Title: **STAGE 1 ROAD SAFETY AUDIT**

Hillhouse, Lucan, Proposed Residential Development.

Report reference: **1495R01**

VERSION: **FINAL (30-7-2022)**

Drawing P22-026-DG-SP-001 S0, Rev 2.0 – Disabled Parking Space.

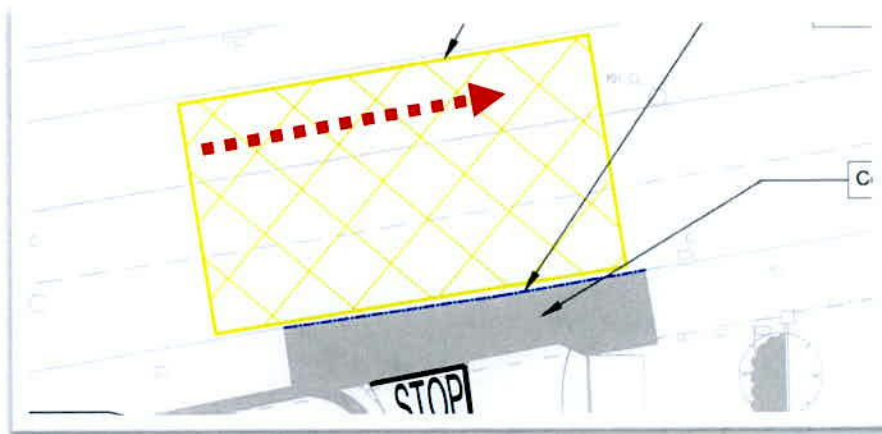
It is unclear if there is sufficient space for a user of the disabled parking space to easily enter/exit the parking space given the proximity of the boundary walls. A lack of space could lead to material damage of vehicles.

It is recommended that a swept path analysis be carried out to ensure that sufficient space is available.

Drawing P22-026-DG-GA-001 S0, Rev 2.0 – Yellow Box.

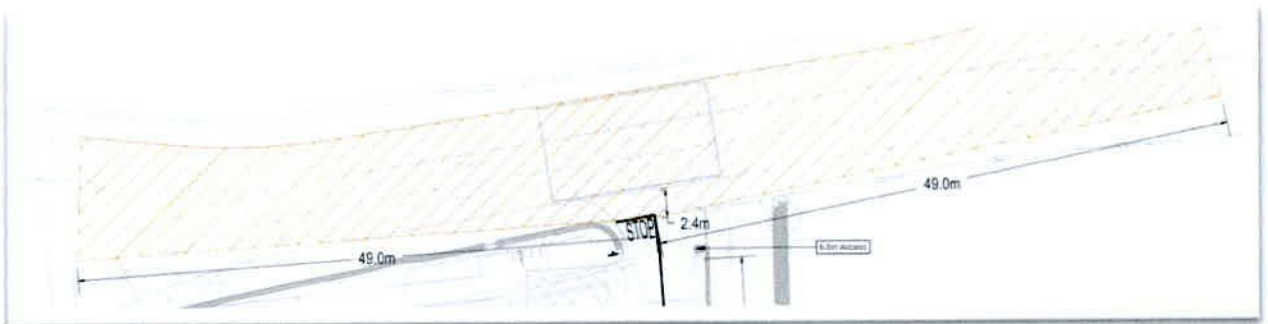
It is unclear if the proposed yellow box is required on the outbound lane from Lucan on the Lucan Road. If queues of traffic do not form in that direction drivers exiting the development during peak periods of inbound traffic may mistakenly think that they can turn right without checking for oncoming outbound traffic resulting in side-impact or rear-end collisions.

It is recommended that the Design Team confirms if outbound queuing takes place and if not, that the yellow box only be provided on the two inbound lanes.

Drawing P22-026-DG-VE-001 S0, Rev 2.0 – Visibility Splays.

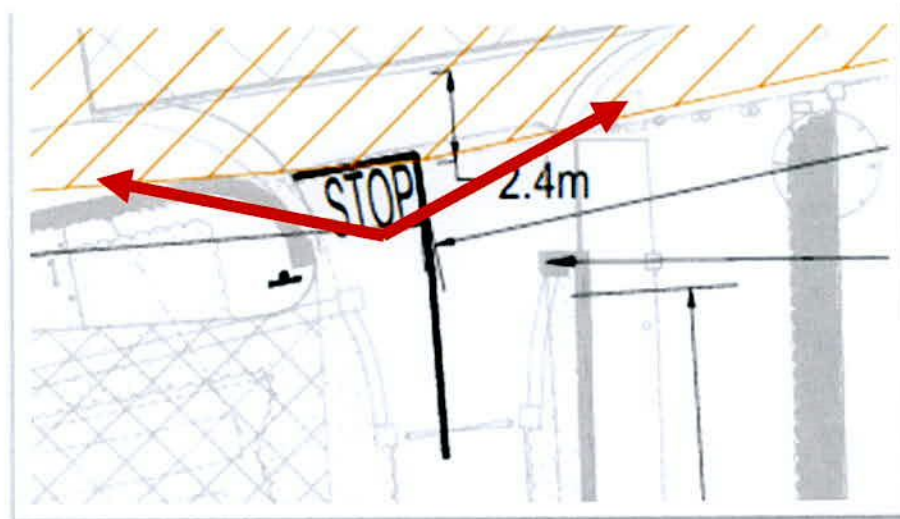
The proposed visibility splay lines cut through both existing and proposed obstacles (vegetation, walls etc.). These obstacles will obstruct visibility for drivers exiting the development and could lead to side-impact or rear-end collisions.

It is recommended that the visibility splays be kept clear of obstacles except for those that are momentary obstructions both individually and cumulatively.
